# Ohio Department of Natural Resources

Division of Mineral Resources Management

Subject: Mining Application IM-10428

After reviewing the mining application the following revision are necessary.

**1**  
 SHEET  
 1  
 DATE: 11/10/11  
 PROJECT: SITE PLAN FOR MINING PERMIT APPLICATION FOR T.V. INC. GRADING  
 CLIENT: Hill & Associates, Inc.  
 DRAWN BY: [Signature]  
 CHECKED BY: [Signature]  
 SCALE: [Blank]  
 DATE: [Blank]  
 PROJECT: [Blank]  
 CLIENT: [Blank]

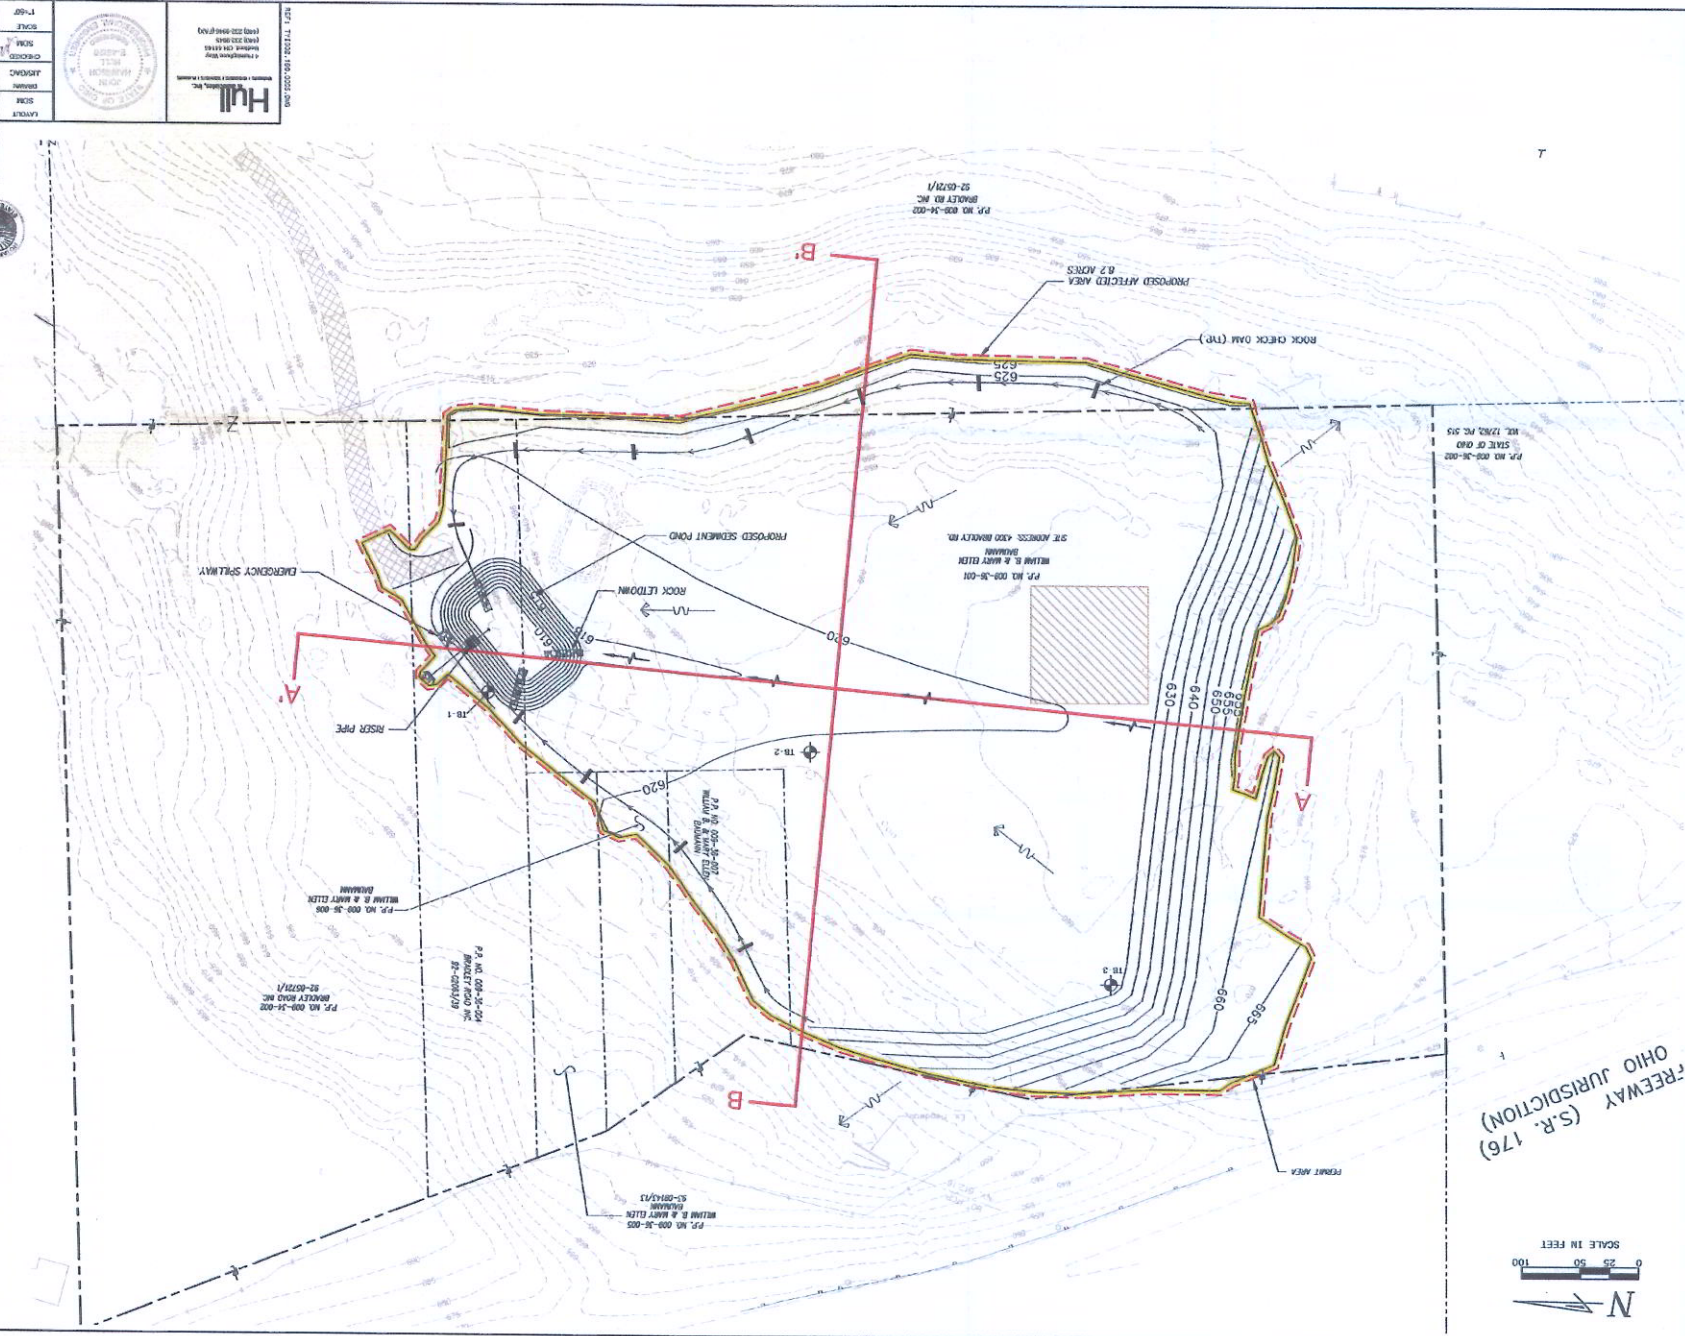
Application map:

1. Identify the landowner to the west of the permit, adjacent to S.R. 176. If property is not owned by the permit holder permit acreage will need to be revised. Also a statement will need to be added that no mining will take place within 50' of the adjacent landowners property.

2. Show section lot lines.
3. Location map shows location is in Westlake, please revise.
4. Existing Stream line needs to be blue.
5. Existing and proposed sediment ponds and permanent impoundments shall be shown on the map and identified by name and number outlined in blue.

6. VMS coordinates need to be shown on the map.
7. Add S&M under owners name showing they have surface and mineral rights. If only surface rights are held please identify on the map, same with mineral rights.

8. Show within 500' Utility lines, buildings, and S.R. 176 right of way. Is the fence line the edge of the right-of-way?
9. GDR reports in the application and test holes on the application do no match. GDR reports are number 1,2,4 test holes are numbered on the application 1,2,3.

10. Revise map scale to 1 inch equals 100 feet to show are within 500' of the permit or extend map at current scale to include area within 500'.
